**STRUCTURAL
CALCULATIONS**

Nestler-Spare Residence
8265 SE 61st St.
Mercer Island, WA 98040

NESTLER - SPARE

- POST - PERMIT REVISION (#3)

Drawing Title:
Roof Framing Plan

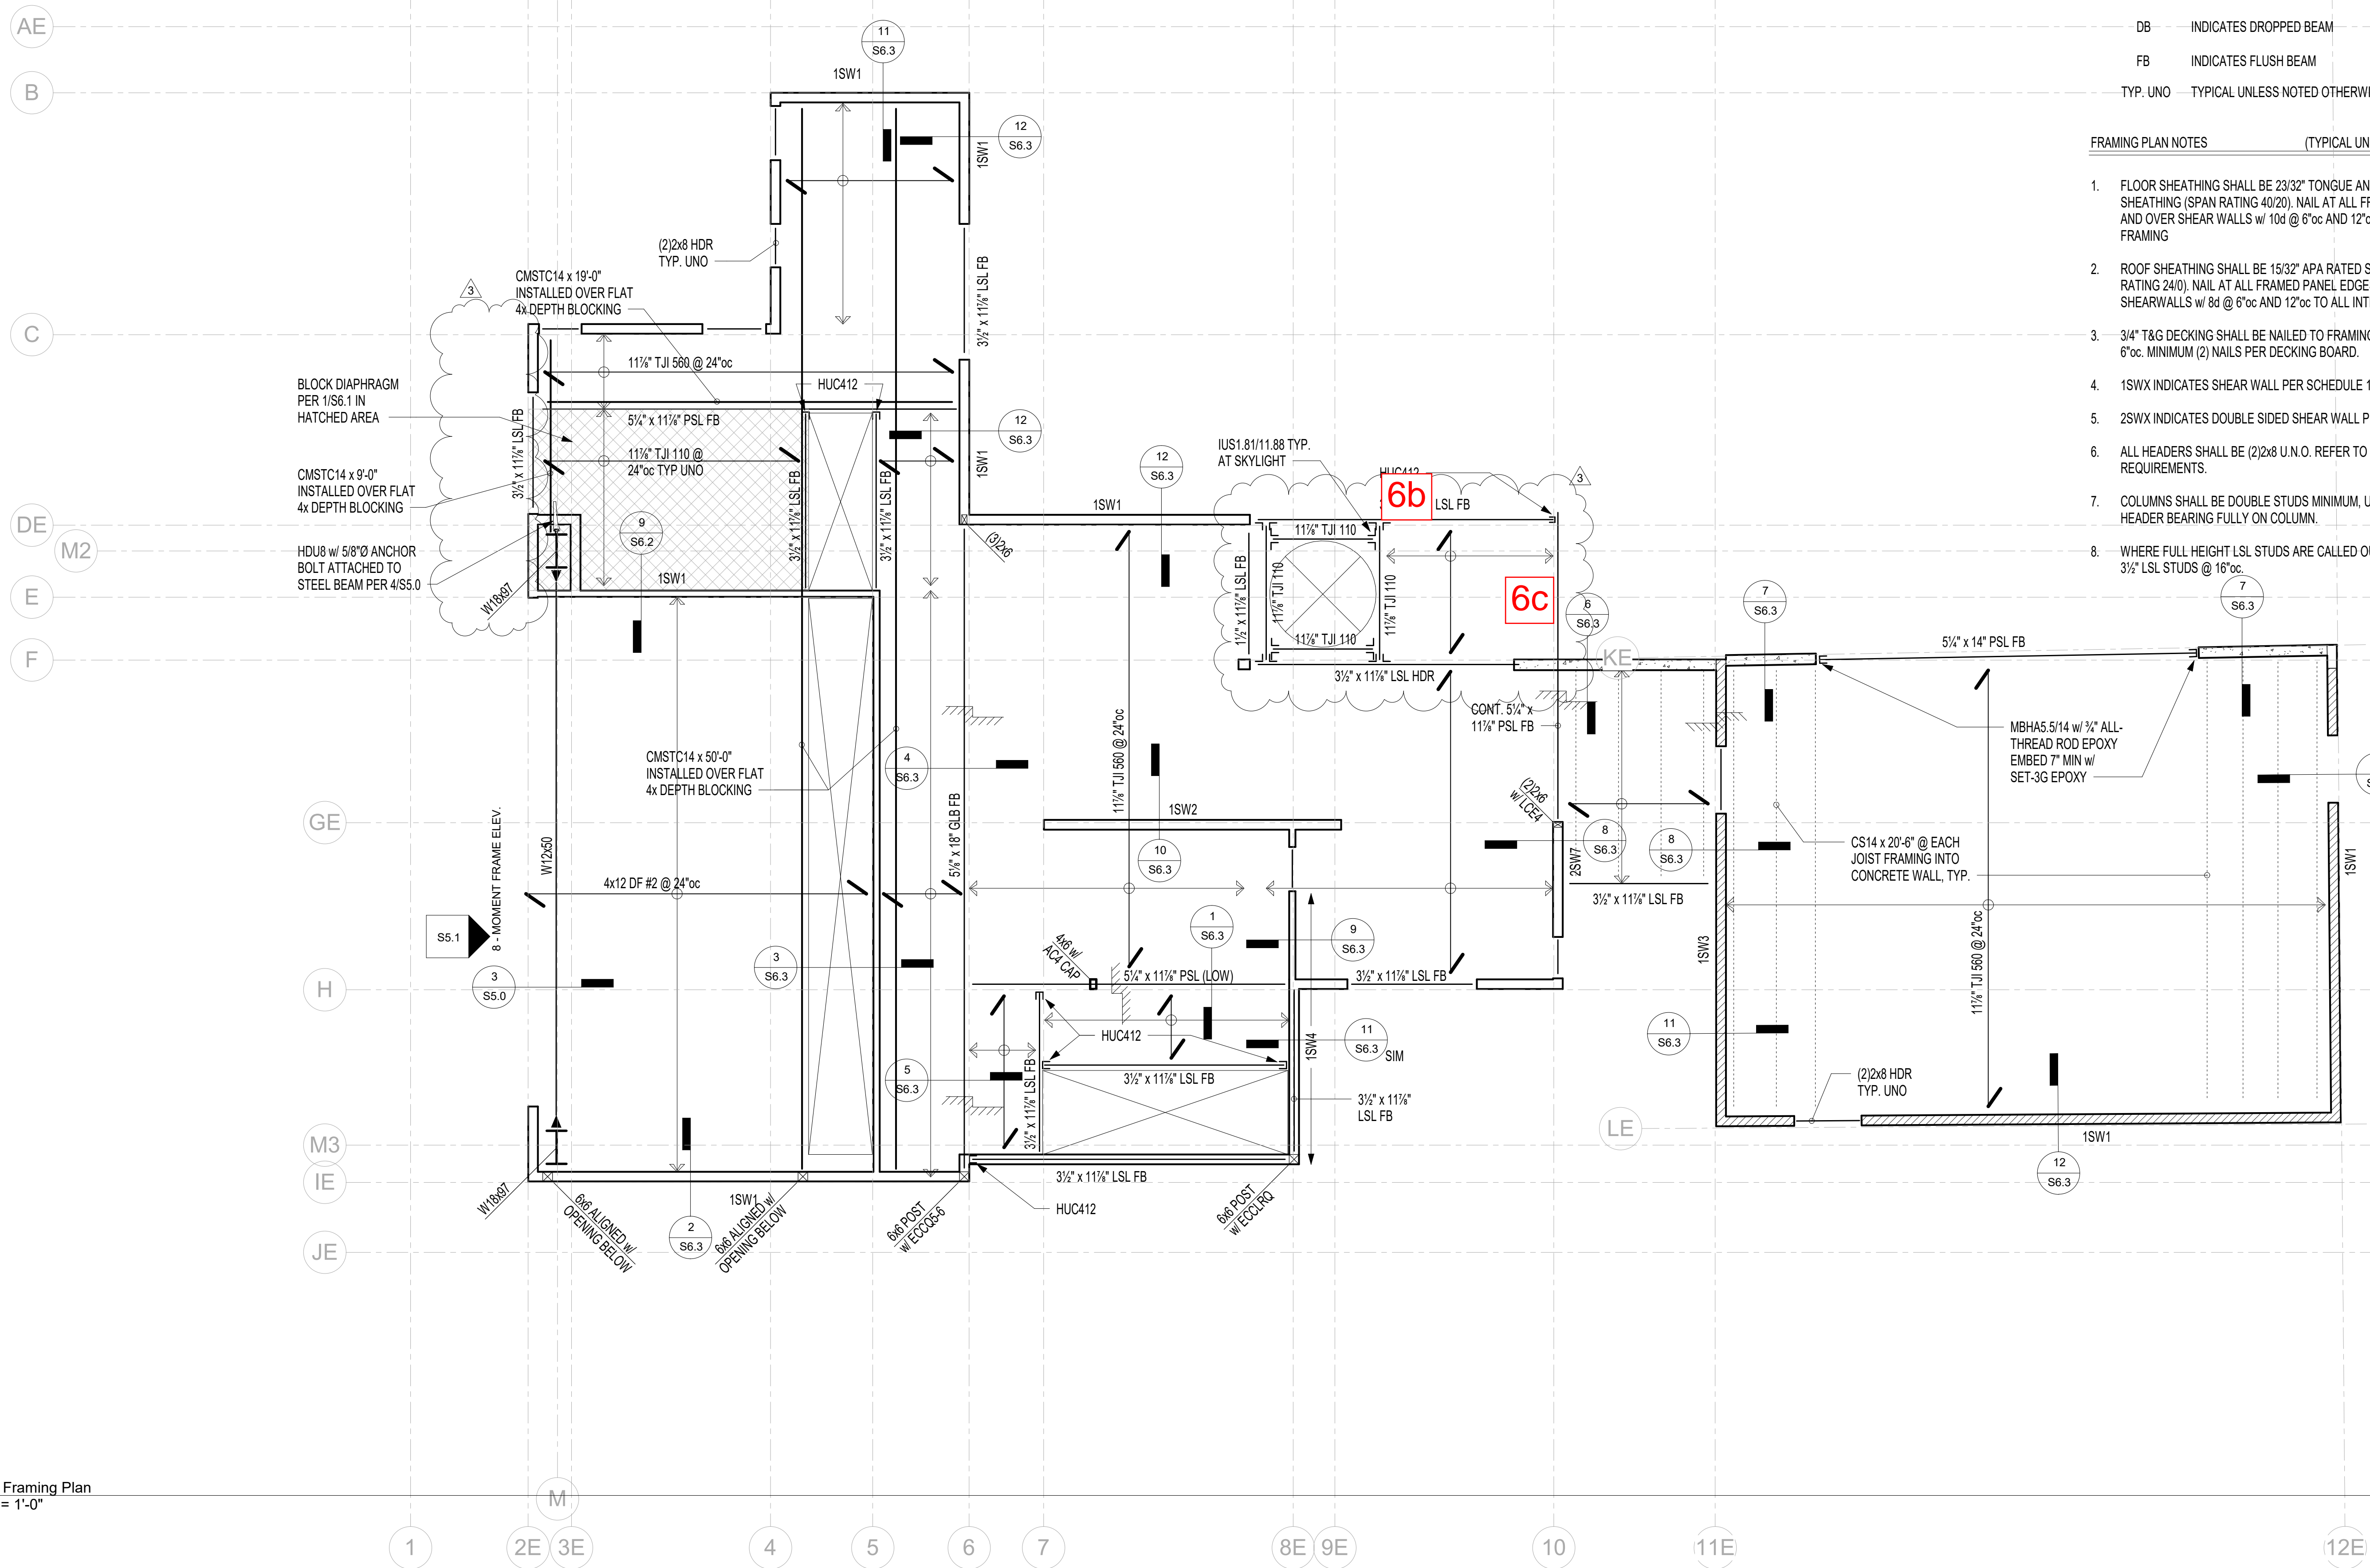
- REVISED FRAMING CALCULATIONS ATTACHED
FOR CHANGED MEMBERS

Drawing Title:
Upper Floor Framing Plan

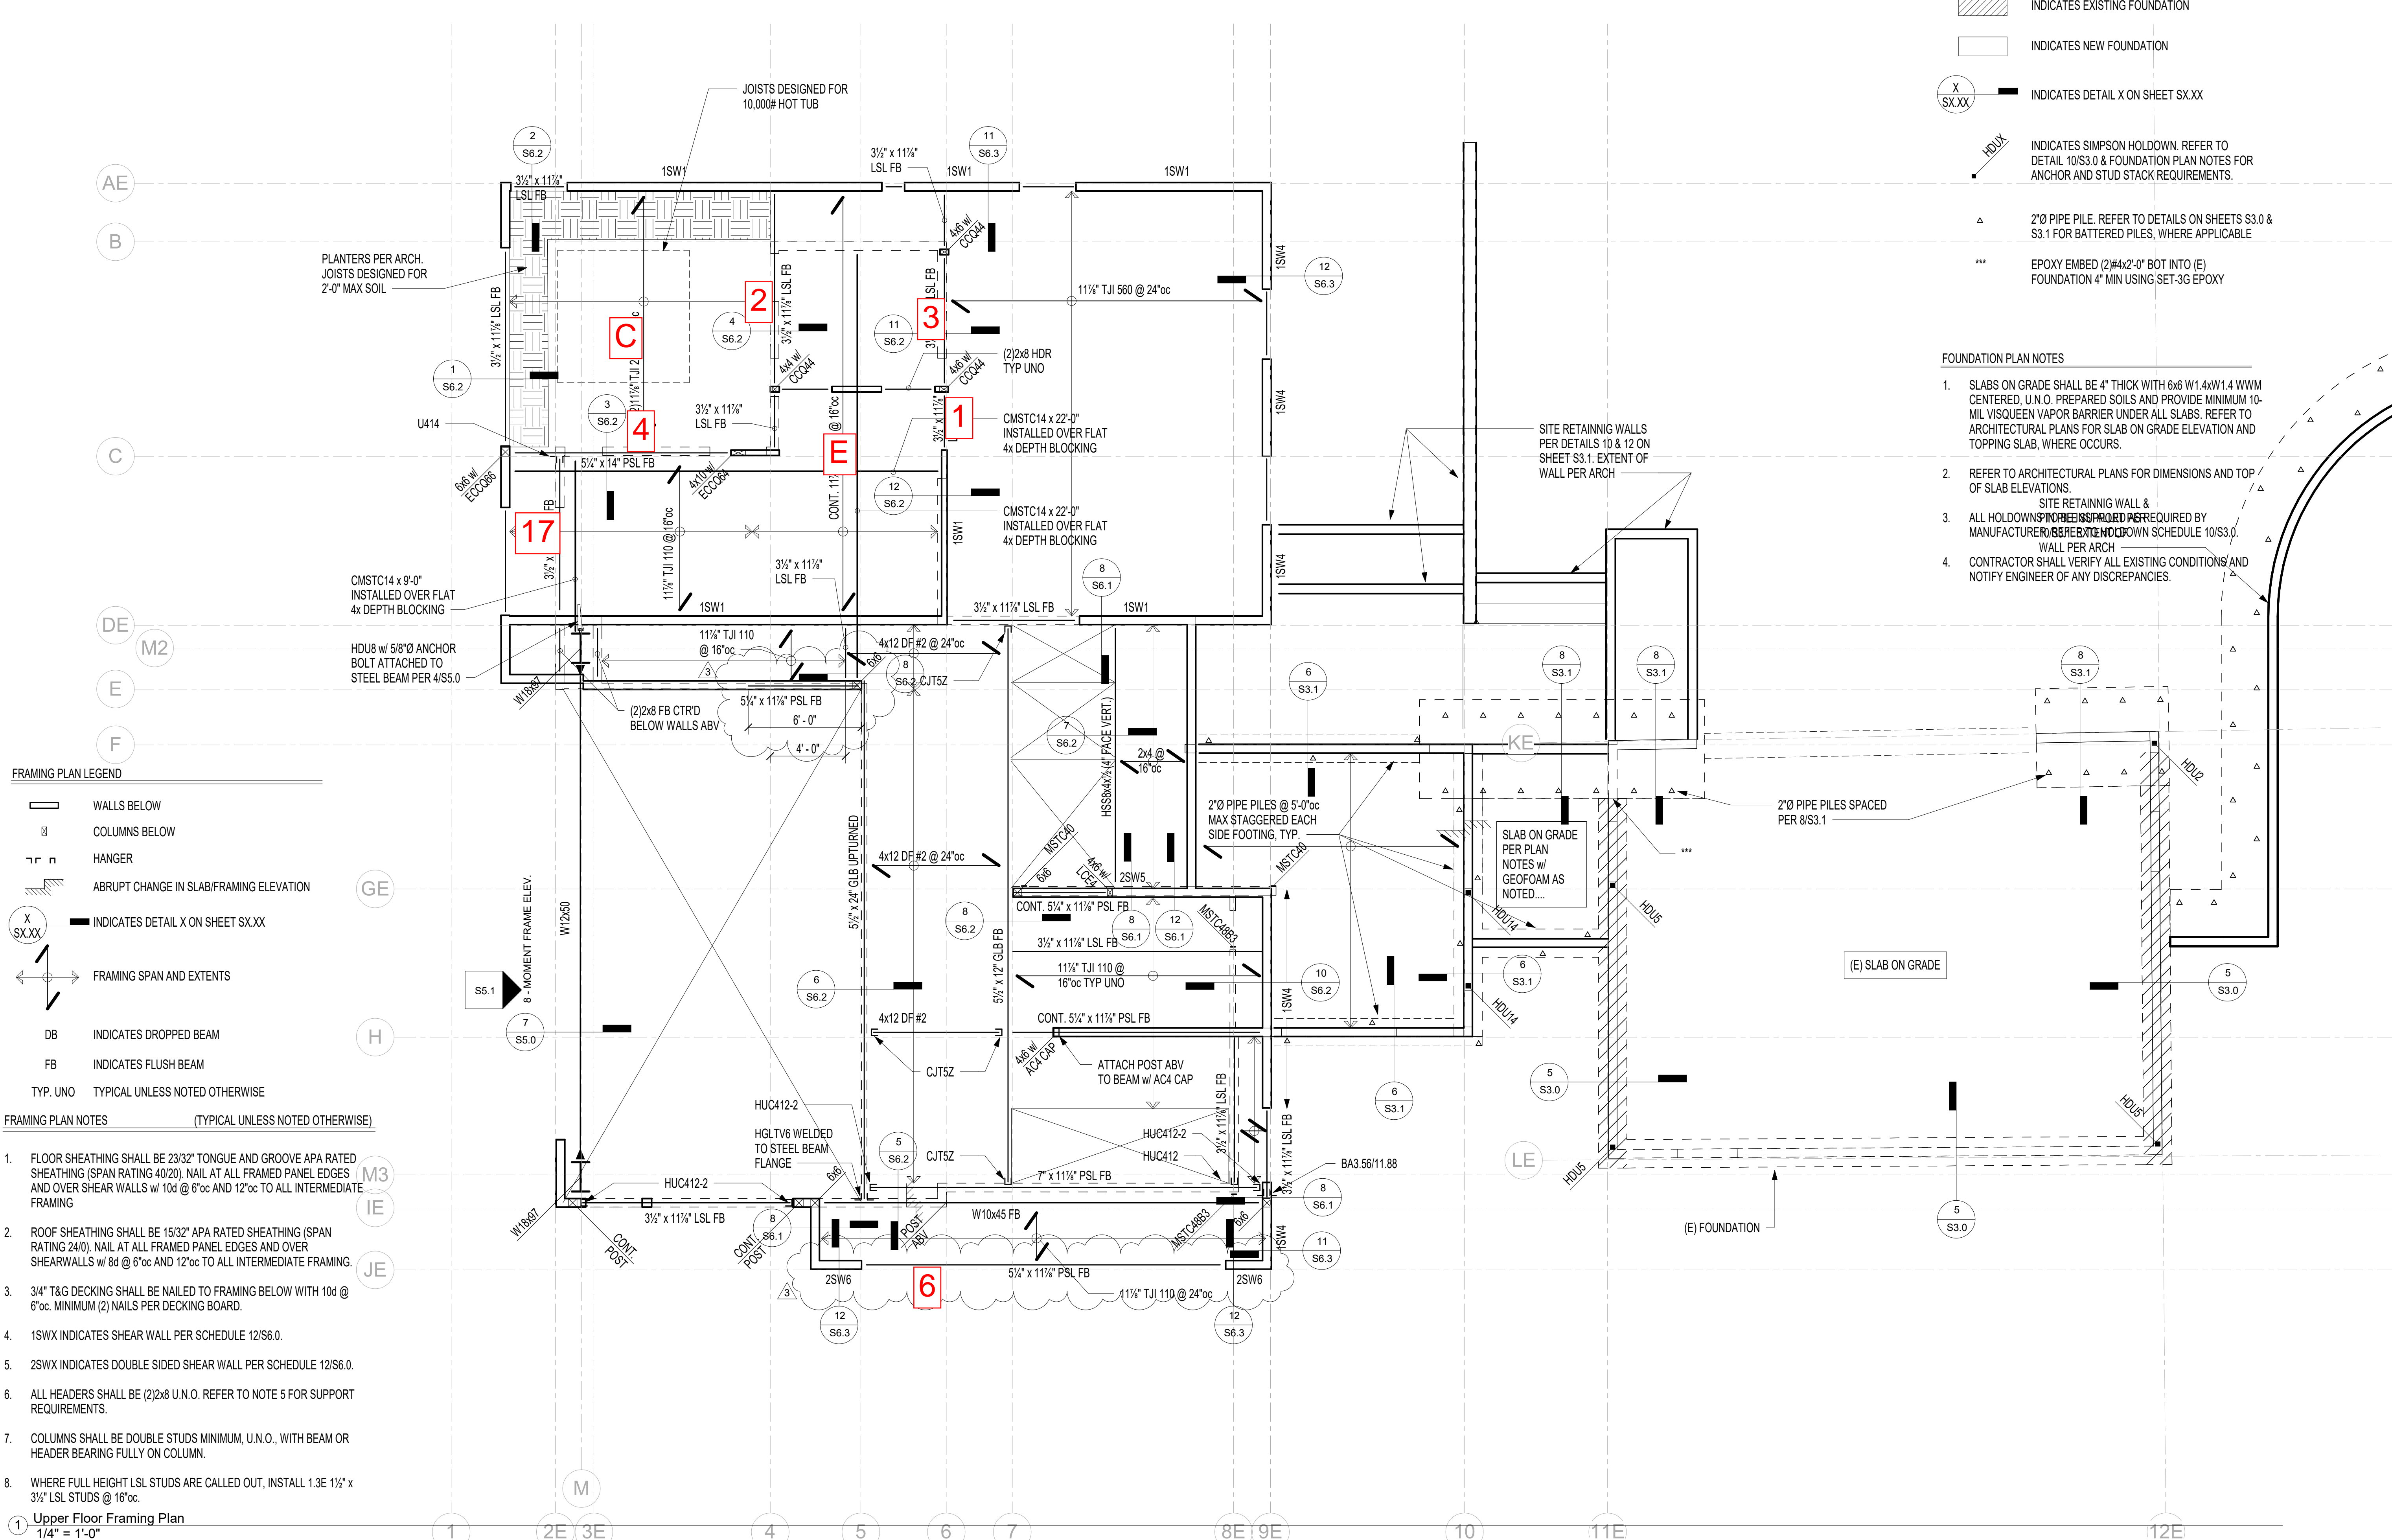
- WALL SHIFTS IN NW CORNER

Drawing Title:
Foundation Plan

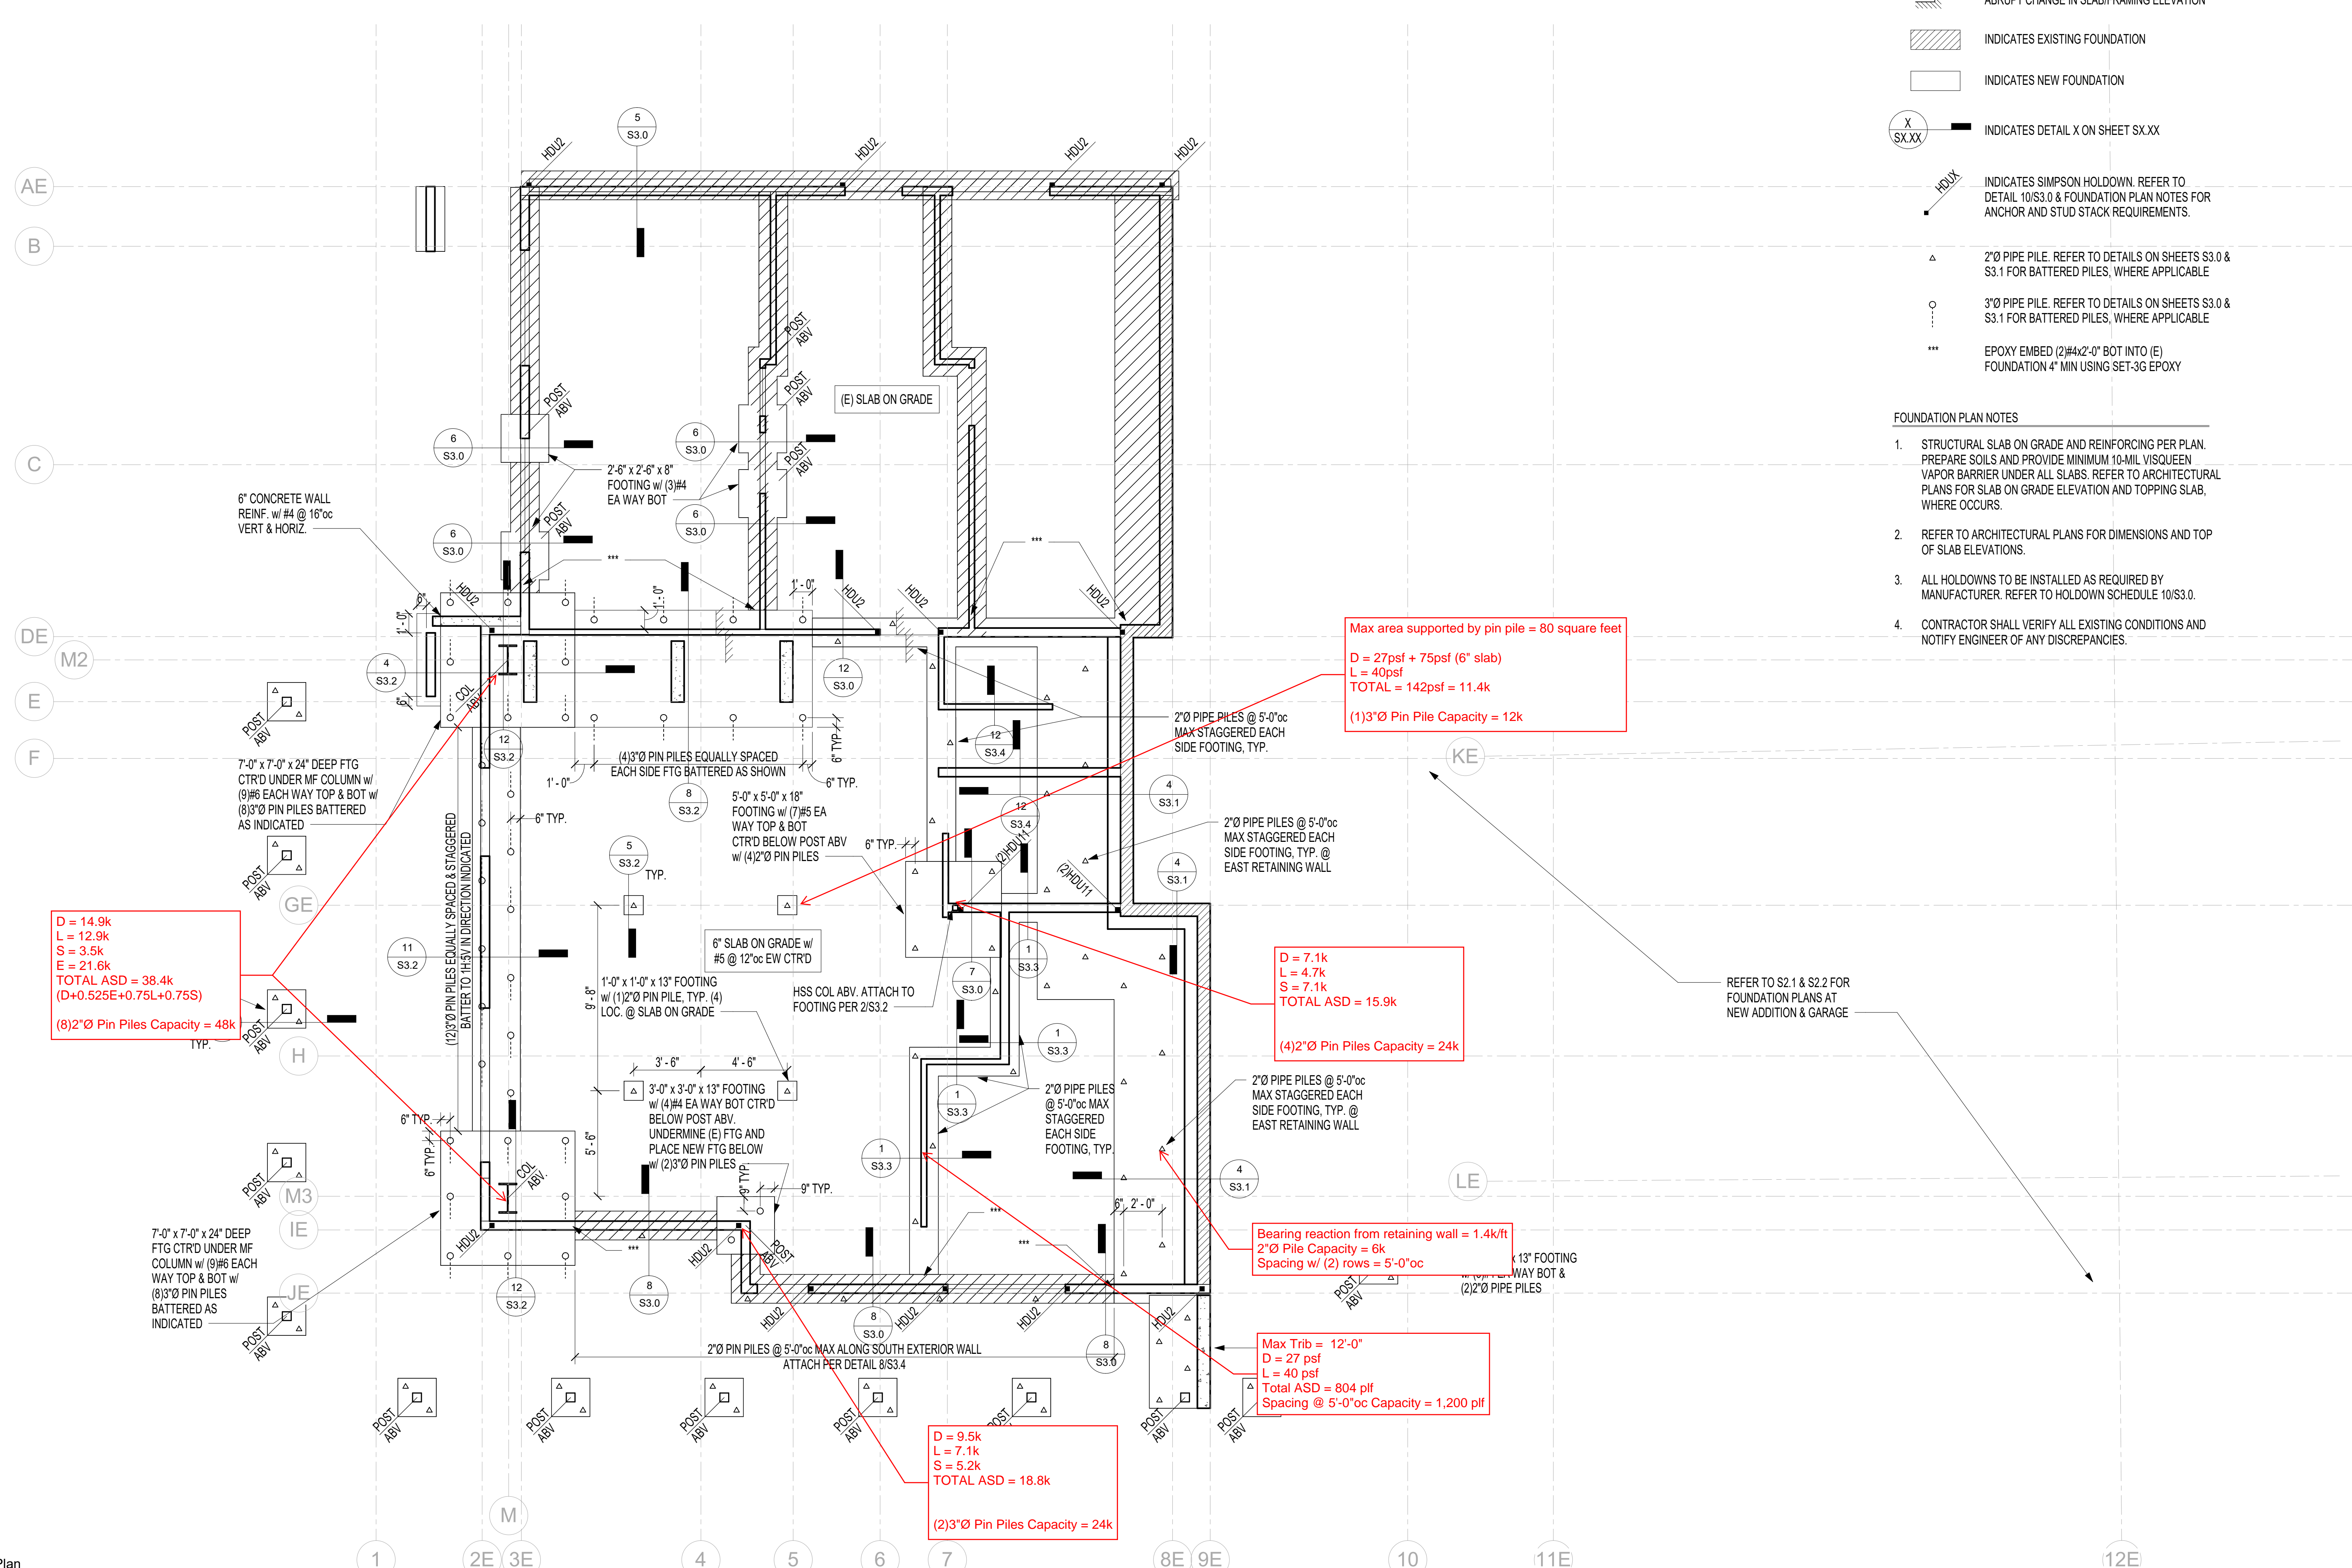
- ADDED PIN PILES TO FOUNDATION PER GEOTECH
